**ADDENDUM NO. 3**

**SPLASH PAD RENOVATIONS**  
**(3% MBE PARTICIPATION GOAL)**

**June 2, 2026**

**SCHEMATIC PIPING PLAN**

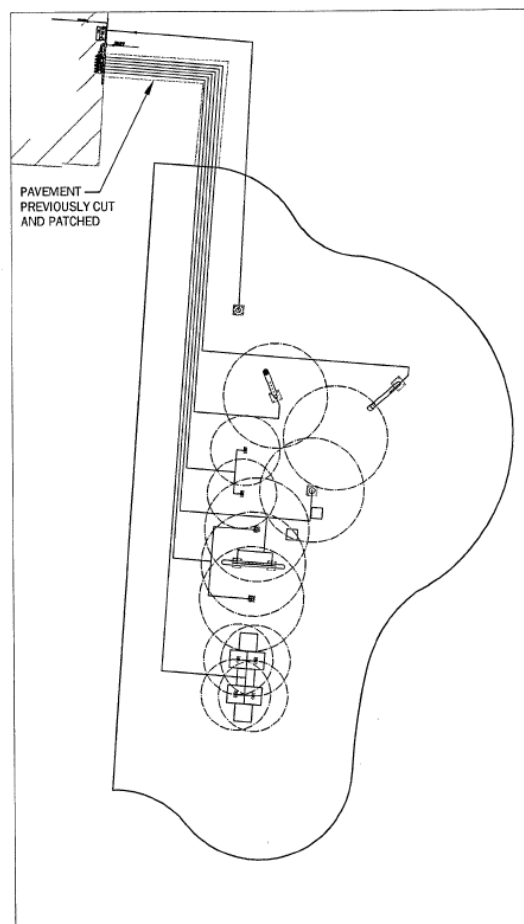
QUESTION #2: Five Oaks – Can you confirm how many lines are going into the site today?

ANSWER: See below for cut sheet from 2007 drawing.

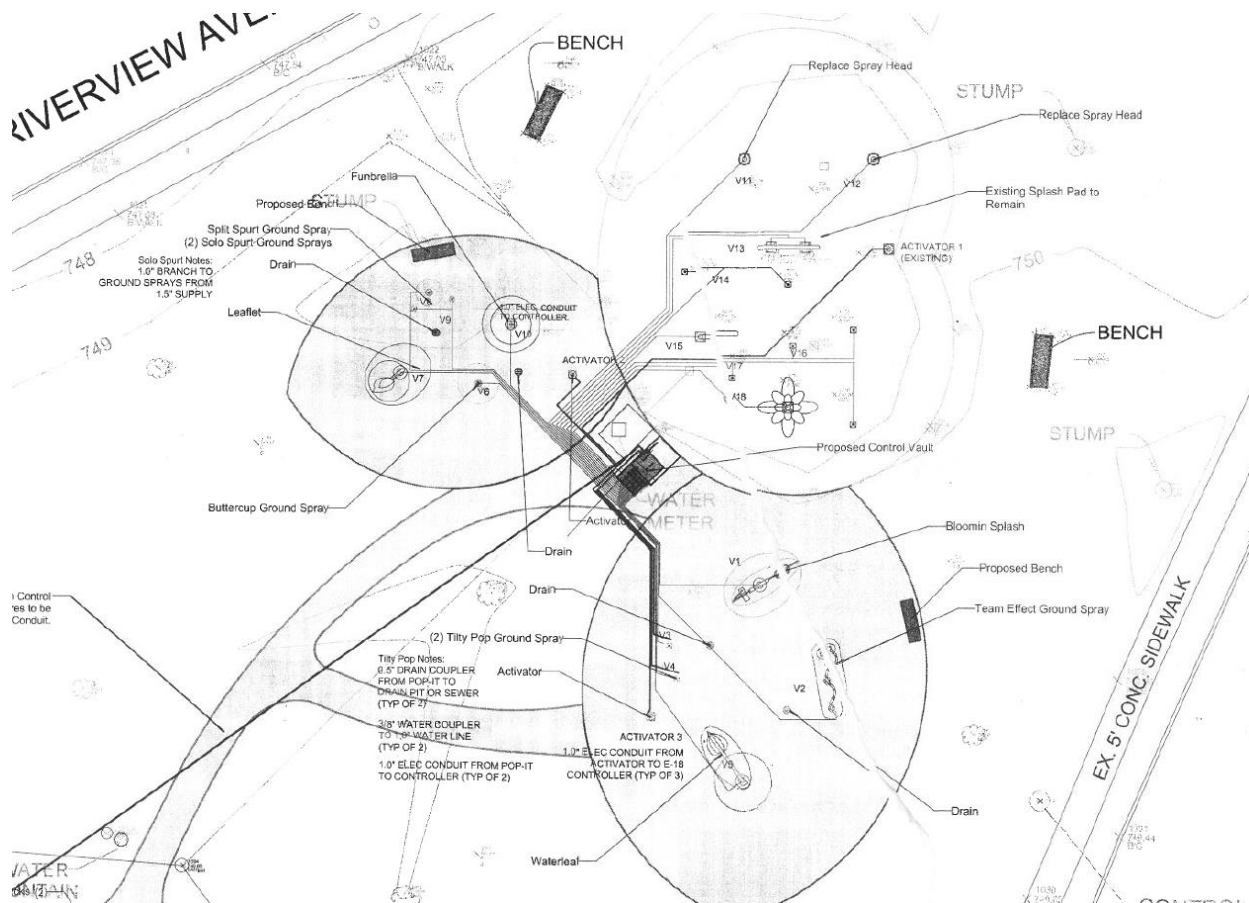
QUESTION #11: McIntosh – The new manifold size is 18 lines are you intending this to support the full space with this kiosk? How many lines are currently allocated to each of the spaces?

ANSWER: Yes, this is the desired intention. See below.

MCTP  
C-131

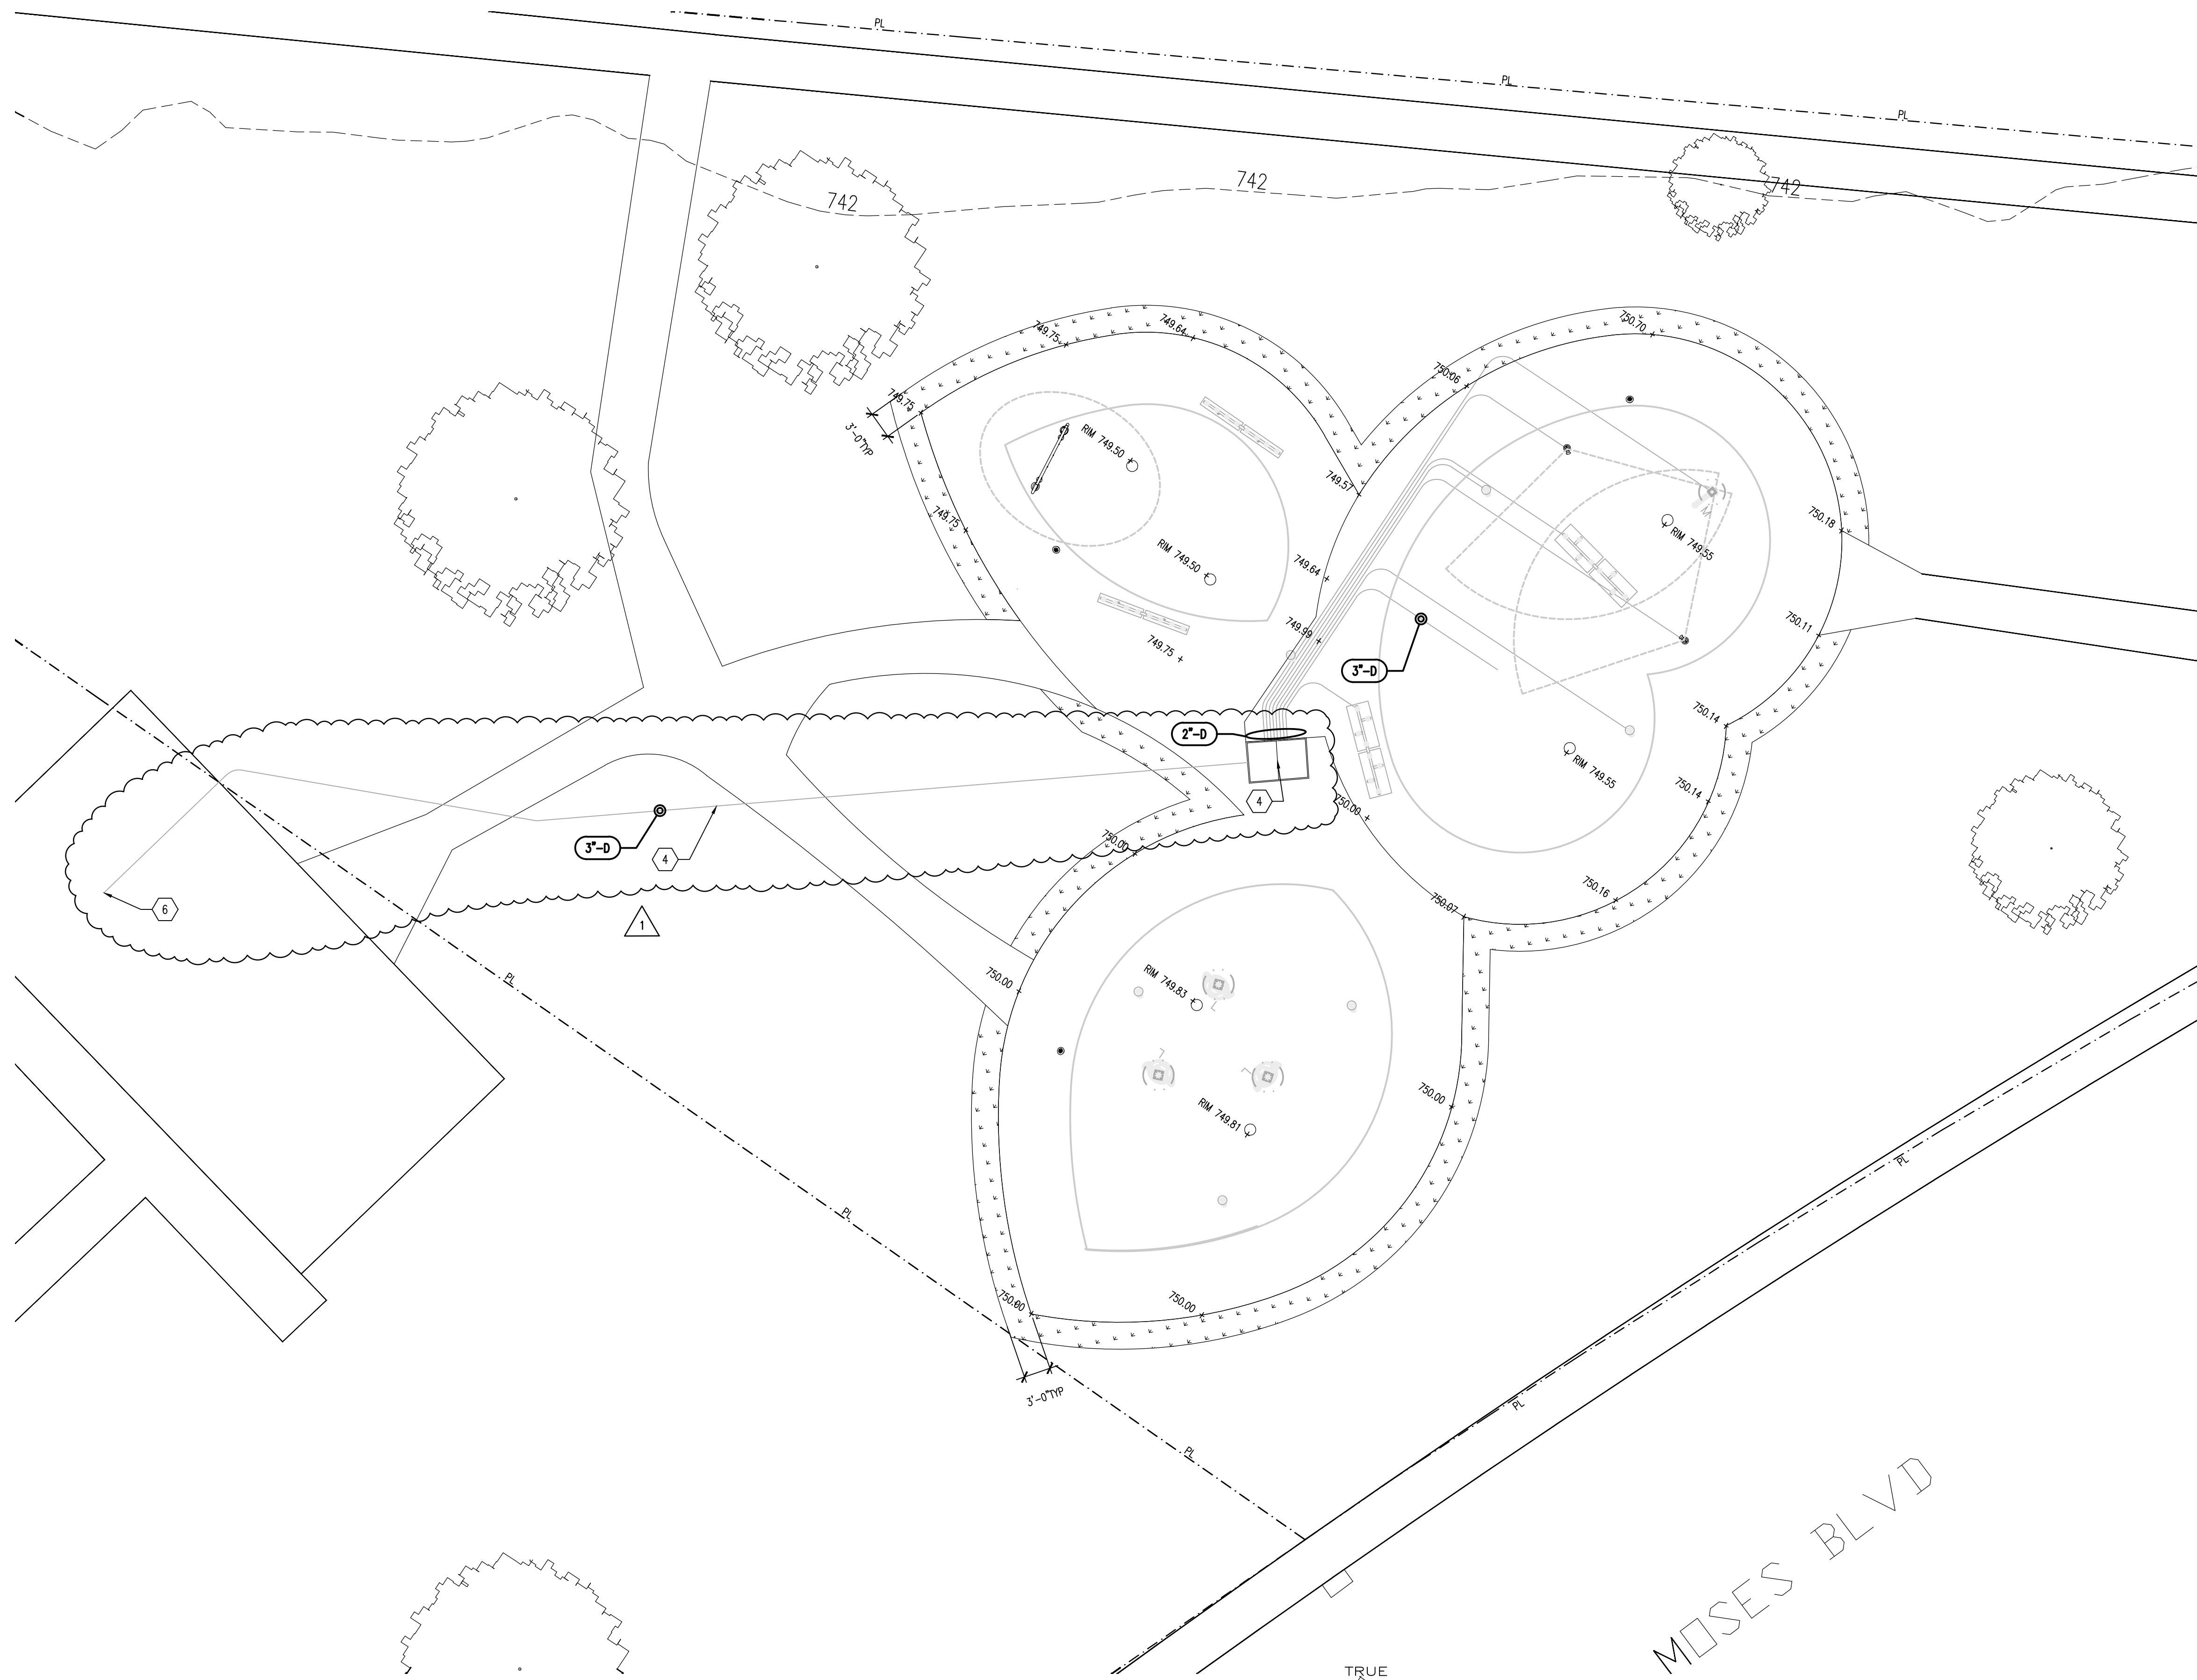
McIntosh: A new 3" water line is required from the existing controller in the park pavilion to the "Aqua Tower" feature. This route crosses existing sidewalks, so the demolition and S.W.P.P plan sheets have also been updated.

MLP  
C-142

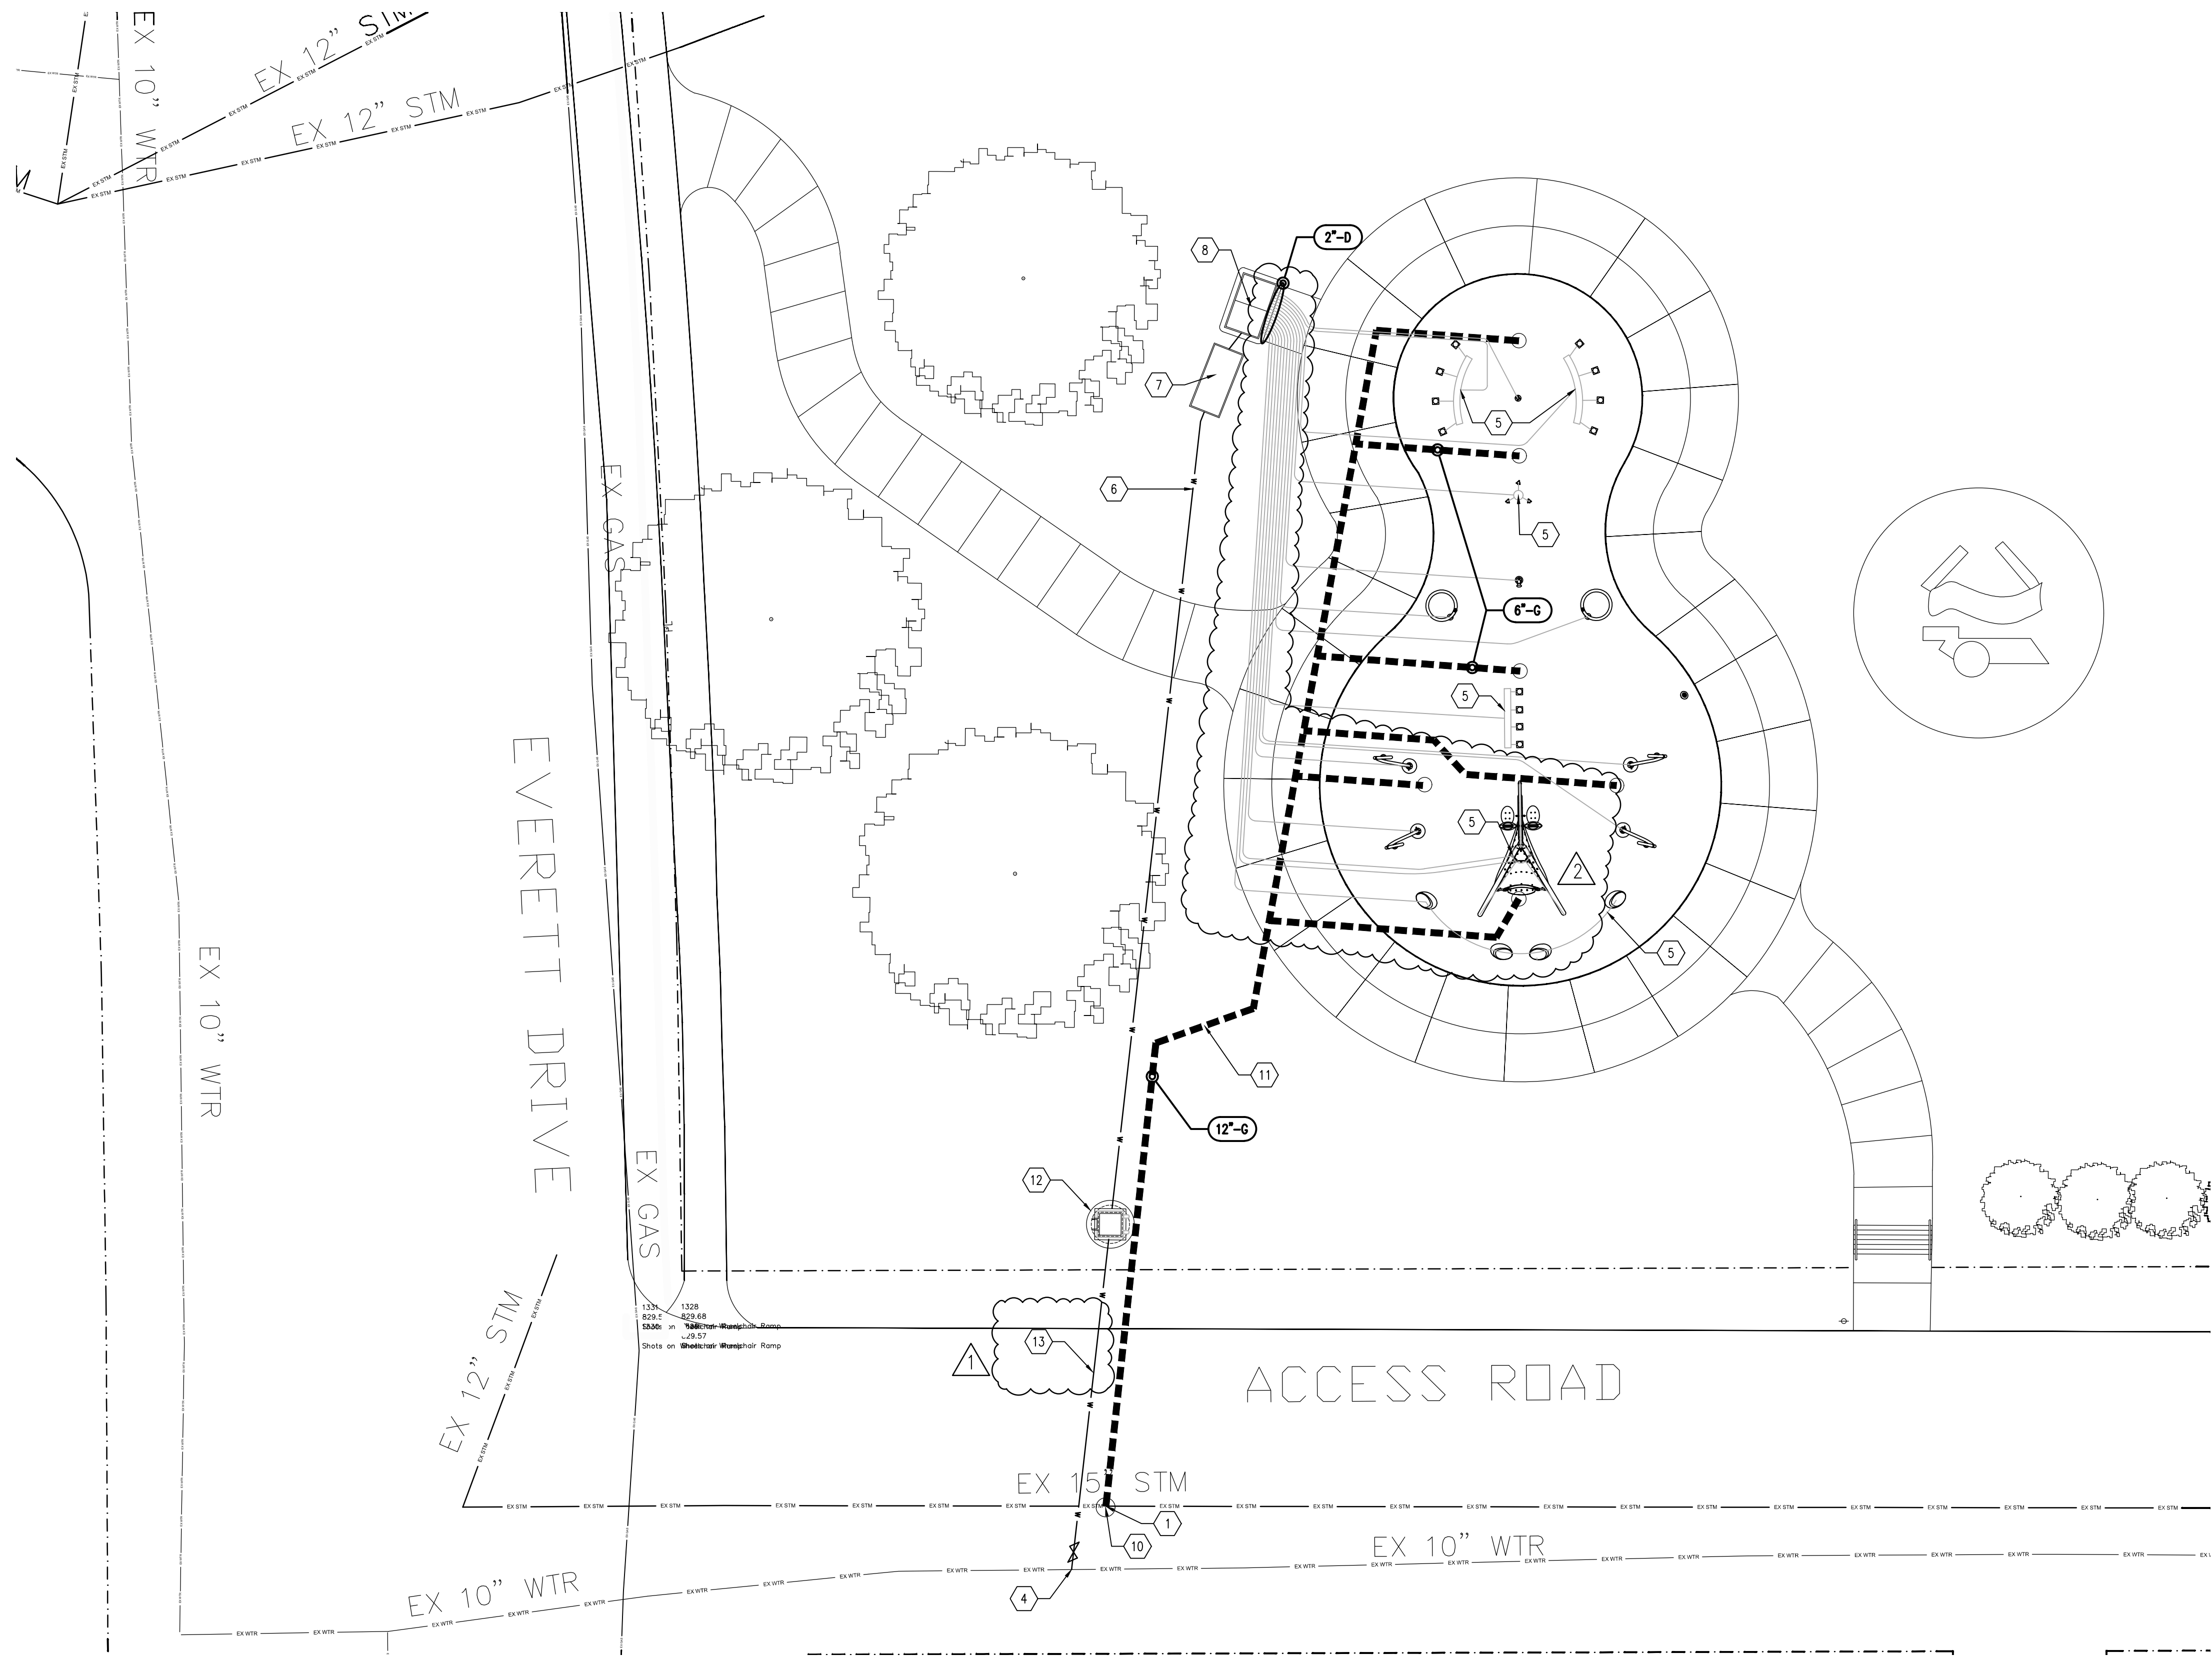
Mallory: The existing “Doughnut Ground Sprays” were mislabeled and have been corrected to show the “Geyser Ground Sprays” currently installed. GPM values and velocity calculations have been updated accordingly.
